The Coors Corridor Plan (the Plan) aims to improve the transportation function of Coors Blvd. and Coors Bypass and to protect the scenic resources of the Corridor as it continues to develop with a mix of uses that better serve residents of the West Side.

October 2014 EPC Red-Line

Figure C-3: Example 6-Lane Typical Sections with CURBSIDE Bus/BRT Lanes for COORS BOULEVARD/COORS BYPASS (NM45)

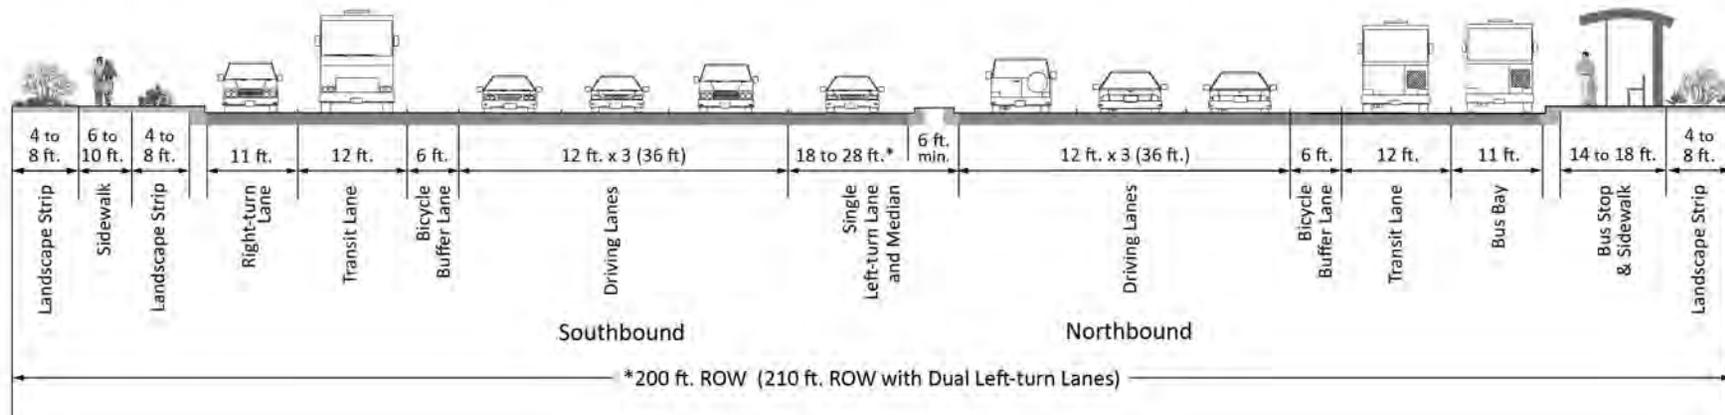
Red = proposed additions Struck-out = proposed deletions

Figure D-10: View Frames and View Area for SDP for Subdivision – Plan View

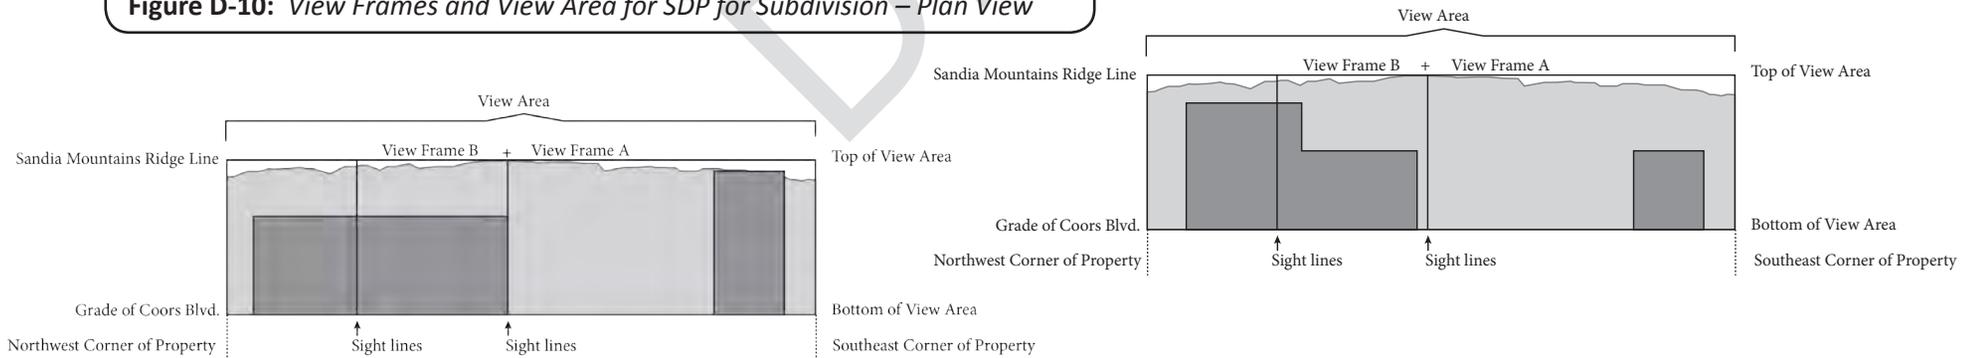
REVISED

Figure D-12: Horizontal View Plane

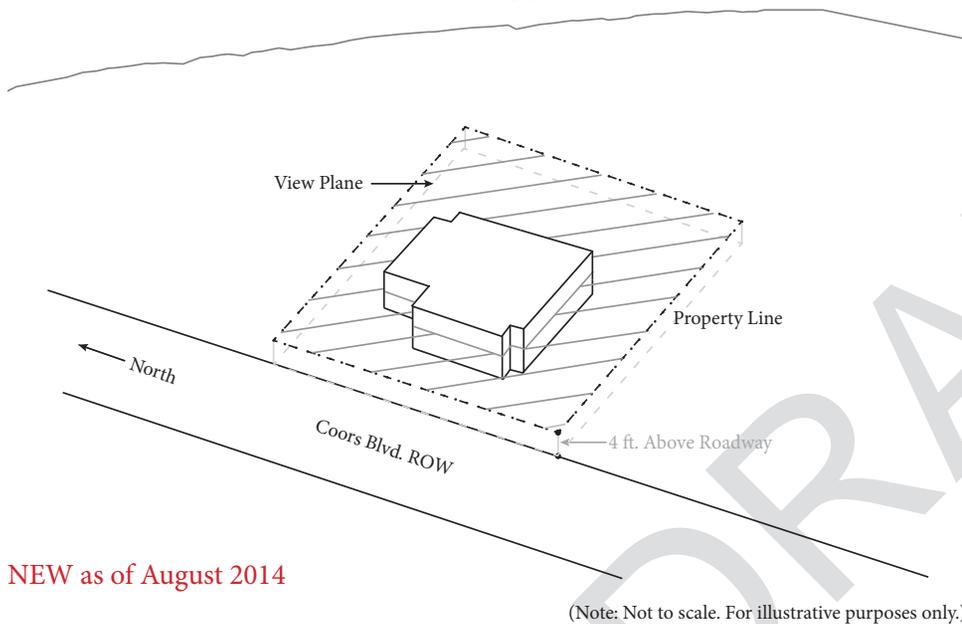
iv) *Horizontal View Plane.* A horizontal plane established at 4 ft. above the east edge of the **existing** pavement of Coors Blvd., **i.e. at the time of application**) [S] ~~that begins at the edge of the Coors ROW and that extends across the site to its eastern boundary.~~ The grade of the pavement reflects the existing condition at the time of application.

NEW as of August 2014
